Queries raised by various vendors through e-mail & during pre-bid meeting of Tender Ref No. :- RGPPL/C&M/CS- 2613/OT-78 dtd. 6th March 2018 and its replies as follows.

AMENDMENT-01 TO TECHNICAL SPECIFICATION (SECTION VI)

ANNEXURE-2(R1)

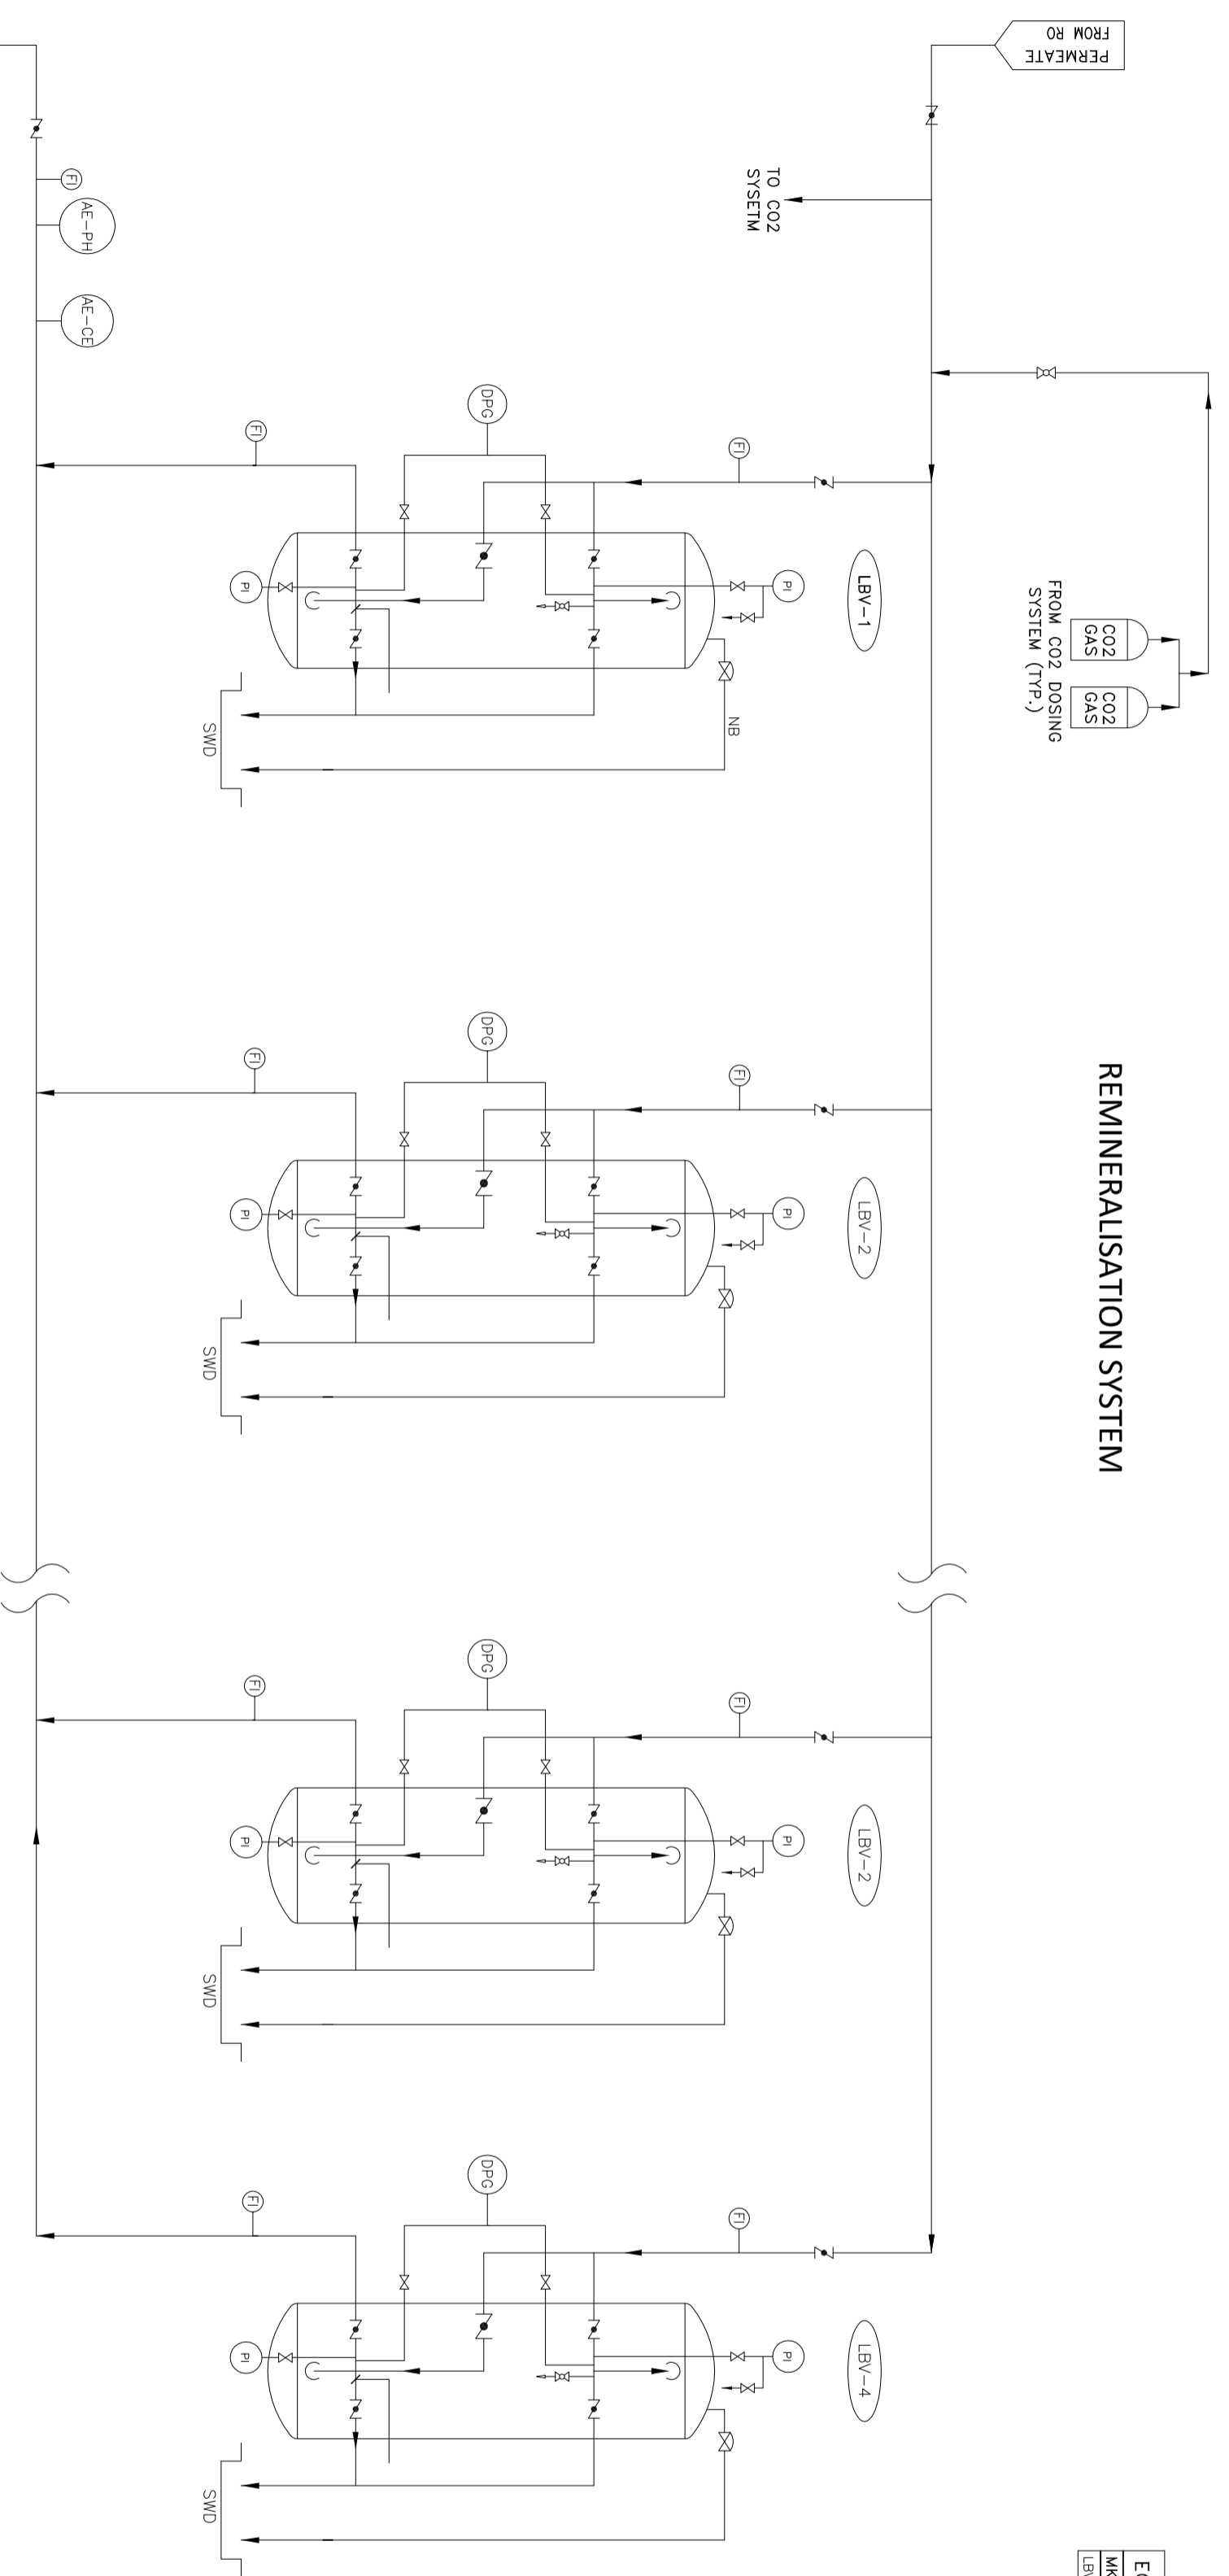
66	TECHNICAL SPECIFICATIONS SECTION VI, Annexure-2 to Sub Sec: IIIA-11(MOC for pipes)	354/1066 Page 1 of 3		Permeate from SWRO plant Lime bed vessel piping... High Austenitic Stainless Steel : 1) UNS S31254 as per ASTM A 182/ASTM A 269 (254 SMO)/ASTM A 312/Equivalent -	SWRO plant permeate and Lime bed vessel piping are low pressure and low TDS application. Hence, super duplex ss with PREN >40 is not required. We propose uPVC/cPVC/ GRP pipes. Kindly accept.	Bidder to refer Amendment No.-01 to Technical Specification
67	TECHNICAL SPECIFICATIONS SECTION VI, Annexure-2 to Sub Sec: IIIA-11(MOC for pipes)	354/1066 Page 1 of 3		5 Degassified water (RO plant) Rubber lined carbon steel.	For degassed water rubber lined carbon steel MOC is not required. We propose uPVC/ cPVC pipe. Kindly accept.	Bidder to refer Amendment No.-01 to Technical Specification
68	TECHNICAL SPECIFICATIONS SECTION VI, Annexure-2 to Sub Sec: IIIA-11(MOC for pipes)	354/1066 Page 1 of 3	General	For all chemical dosing pipes	We propose cPVC sch. 80 for all chemical dosing pipe lines. This is best suitable and proven material for chemical application. Kindly accept.	Bidder to refer Amendment No.-01 to Technical Specification

2.	High Pressure Sea Water and Brine from SWRO plant (From discharge of HP Feed pumps of SWRO plant up to ERU inlet)	High Austenitic Stainless Steel : 1) UNS S31254 as per ASTM A 182/ASTM A 269 (254 SMO)/ASTM A312/ Equivalent - Refer Note * 2) UNS S32750 as per ASTM A 790 / A 182/Equivalent. – (*) Note (*): Having PREN (Pitting Resistance Equivalent Number) greater than 40

3.	Permeate from SWRO Plant (Product water of SWRO Plant to Degassers, piping at the upstream and downstream of product water transfer pumps up to Storage tanks/Potable water treatment system/2 nd stage RO Plant)	High Austenitic Stainless Steel : 1) UNS S31254 as per ASTM A 182/ASTM A 269 (254 SMO)/ASTM A 312/Equivalent - Refer Note * 2) UNS S32750 as per ASTM A 790 / A 182/Equivalent. – (*) Note (*): Having PREN (Pitting Resistance Equivalent Number) greater than 40

REV.	DESCRIPTION	DRAWN	DESIGN	CHKD	M	C&I	C	E	APPD	DATE	PRJCT	TITLE	DWG NO.	SHEET NO.	REV. NO.	SCALE
1	REVISED FOR TENDER									02.04.18	PROJECT	2X40cum/hr DESALINATION PLANT AT RGPLJ.	CW-EN-9886-PVM-A-001 (R1)	8 of 9	1	A1
0.	RELEASED FOR TENDER											P&I DIAGRAM FOR DESALINATION PLANT

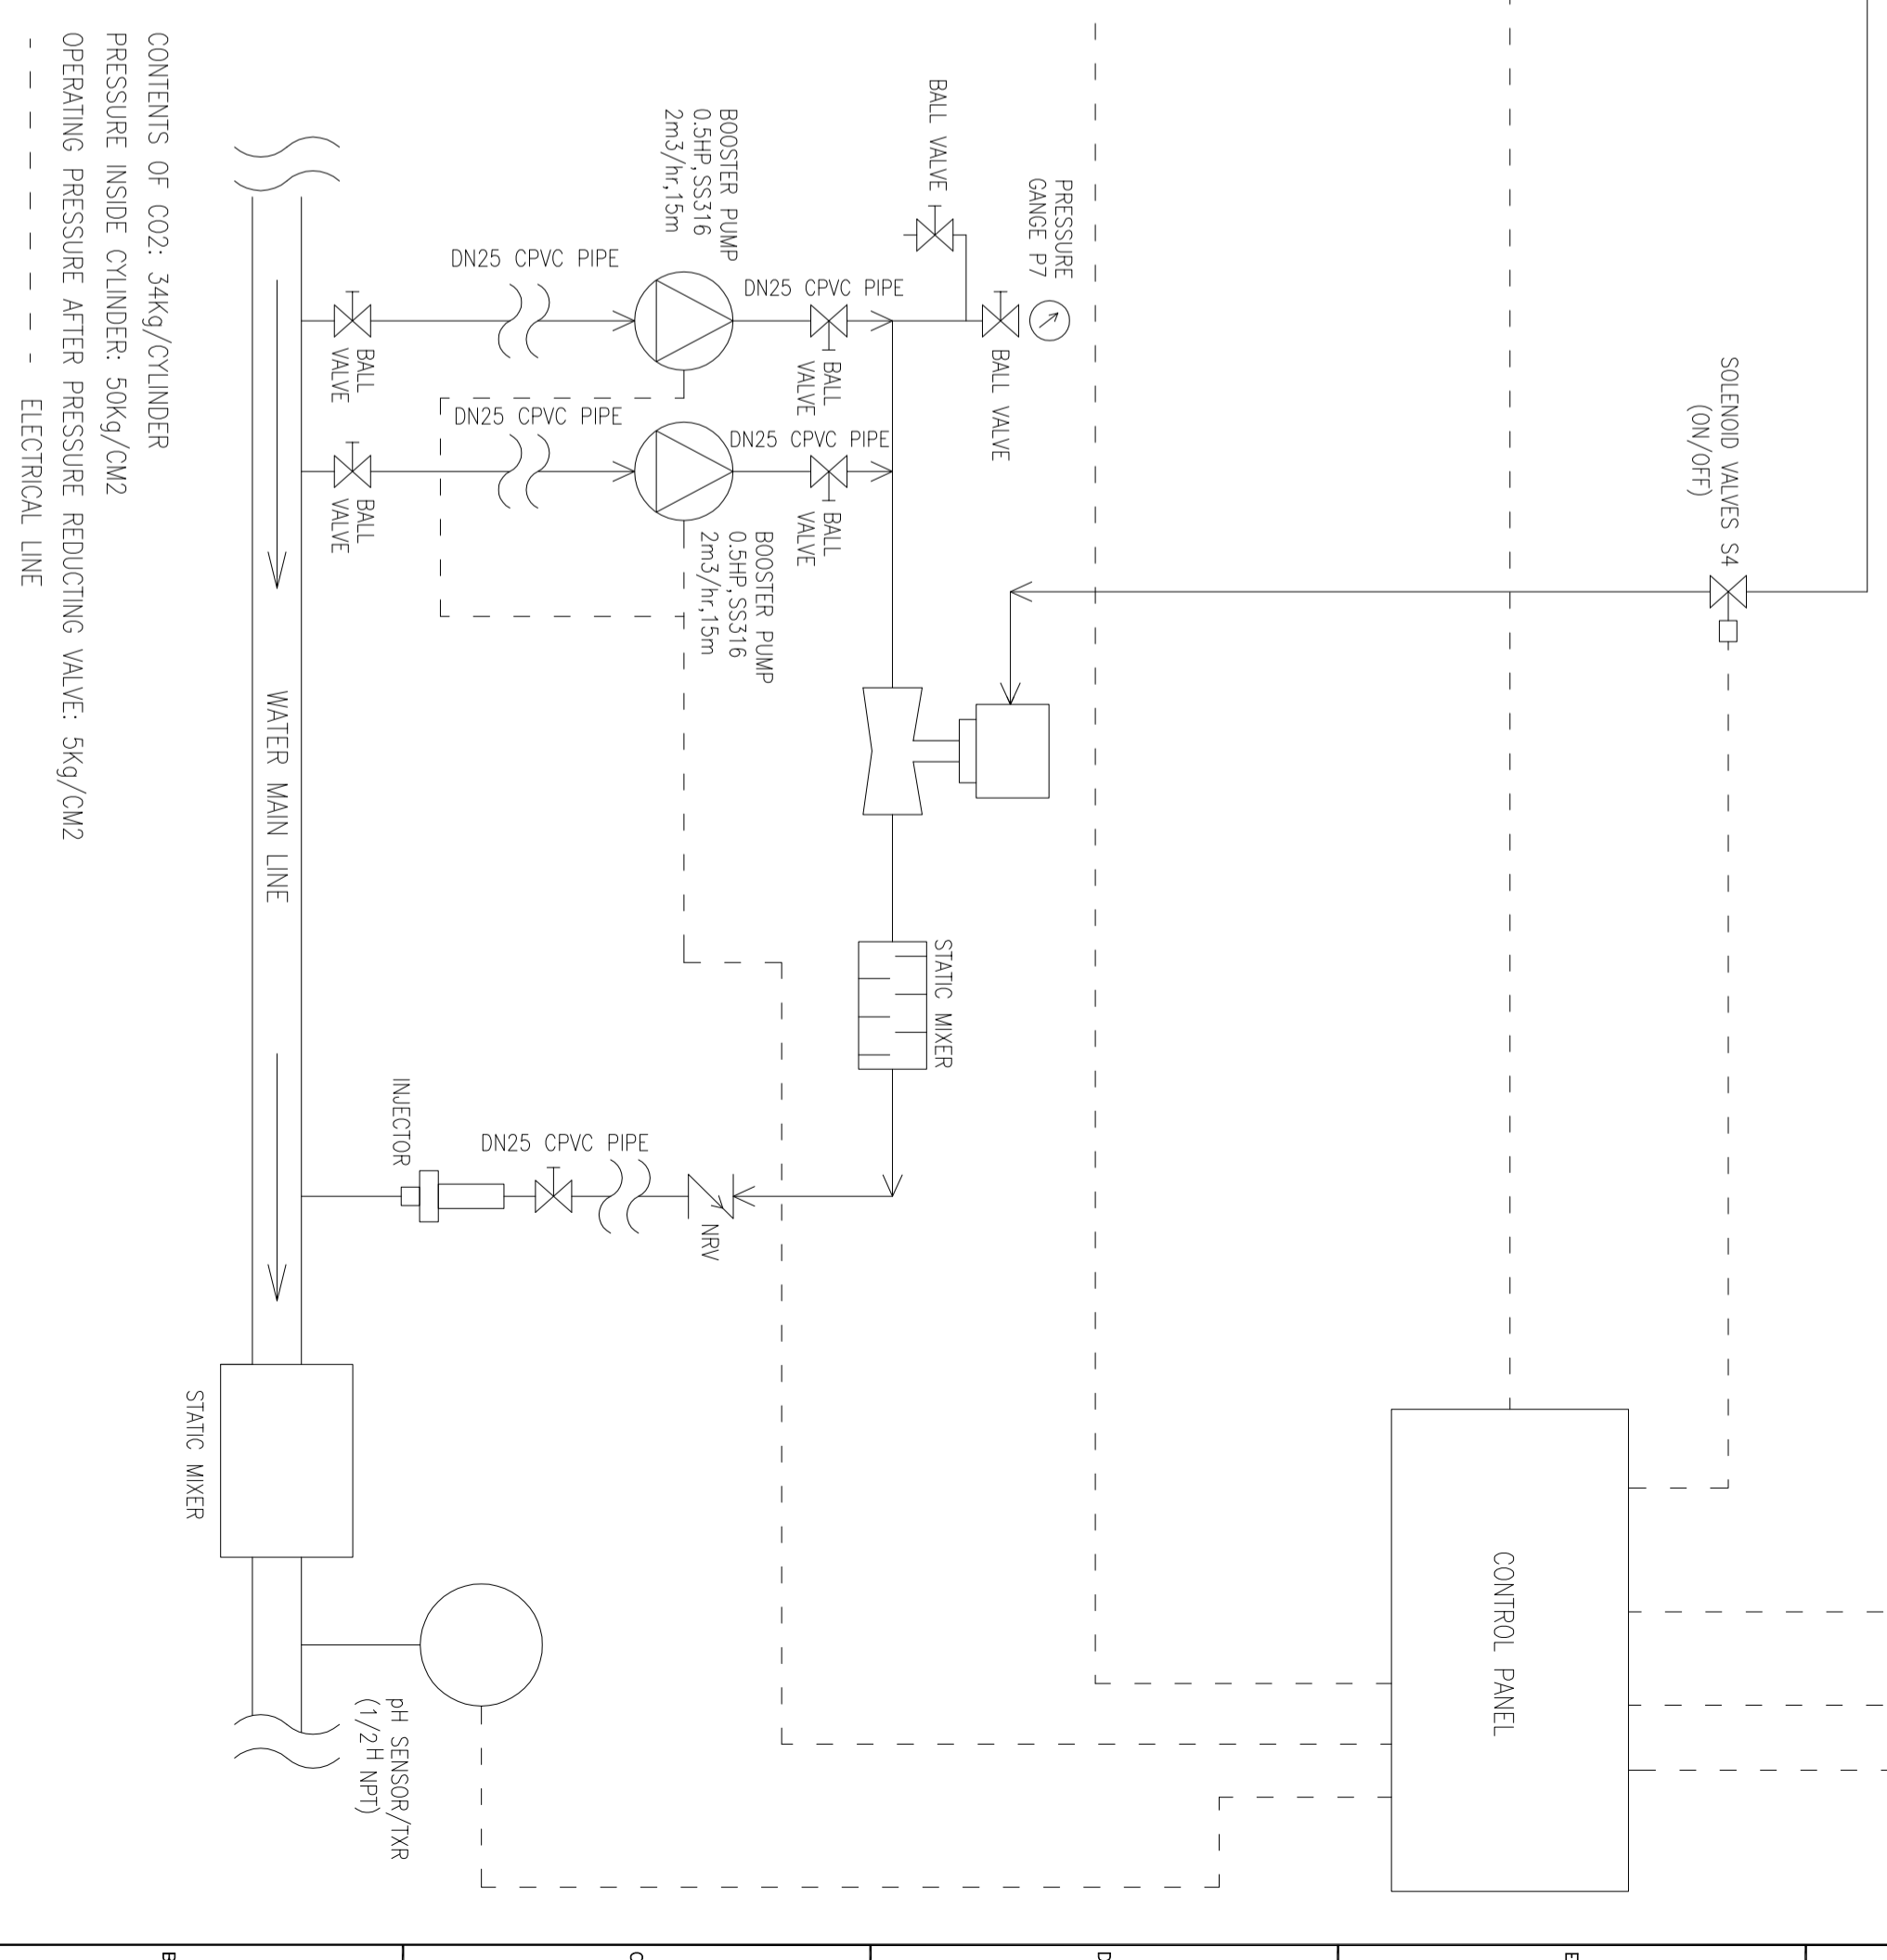
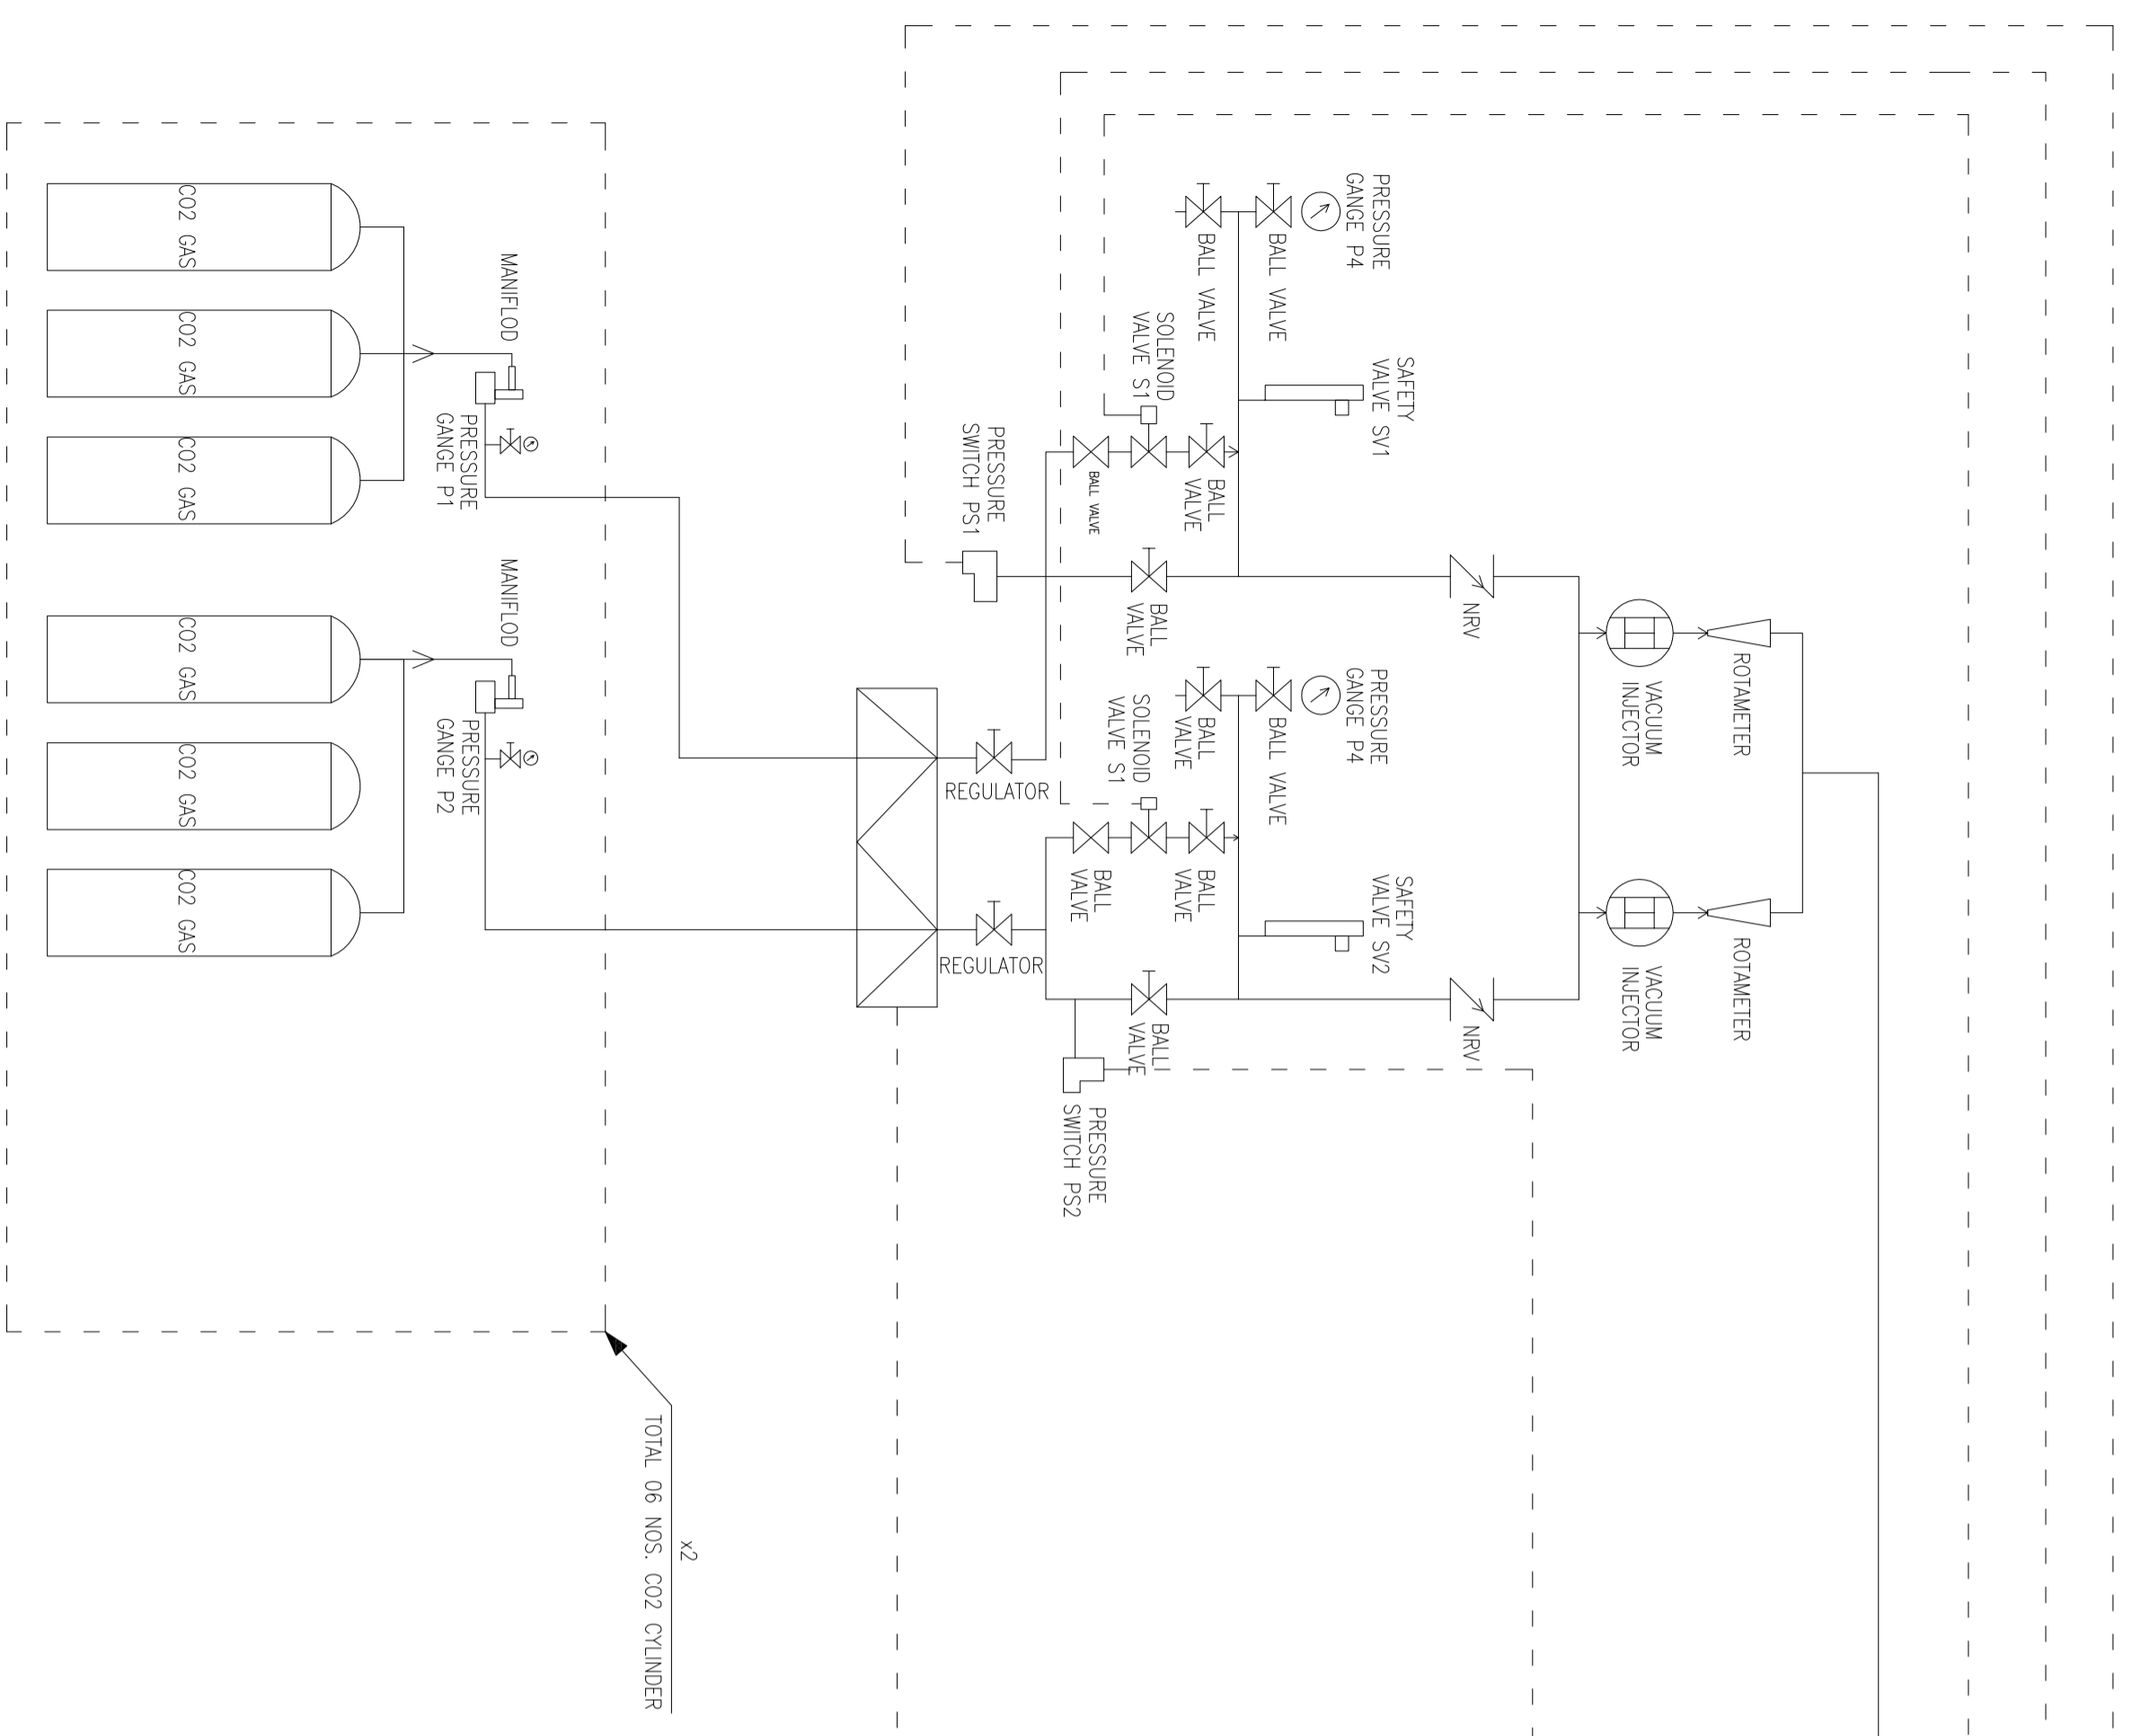
2)	TDS	ppm	Less than 400 ppm considering inlet water temperature upto 30 deg C																															
14	VI / B	IIIA-04 / REVERSE OSMOSIS SYSTEM	12 OF 12	18.02.00	Dosing of acid, alkali and lime shall also be provided to -----one (1) number lime tank of Stainless steel shall be provided with dissolving basket, agitator etc.	Dosing of acid, alkali and lime shall also be provided ----- one (1) number lime tank of Stainless steel / RCC shall be provided with dissolving basket, agitator etc.																												
15	VI / B	IIIA-11 / ANNEXURE-2 (MOC FOR PIPES)	1,2,3 OF 3		ANNEXURE-II	Chapter replaced with chapter ANNEXURE-2(R1)																												
16	VI / E	Tender Drawing	Sheet 7,8,9 OF 9		CW-EN-9886-PVM-A-001 sheet 7 of 9 CW-EN-9886-PVM-A-001 sheet 8 of 9 CW-EN-9886-PVM-A-001 sheet 9 of 9	CW-EN-9886-PVM-A-001(R1) sheet 7 of 9 CW-EN-9886-PVM-A-001(R1) sheet 8 of 9 CW-EN-9886-PVM-A-001(R1) sheet 9 of 9
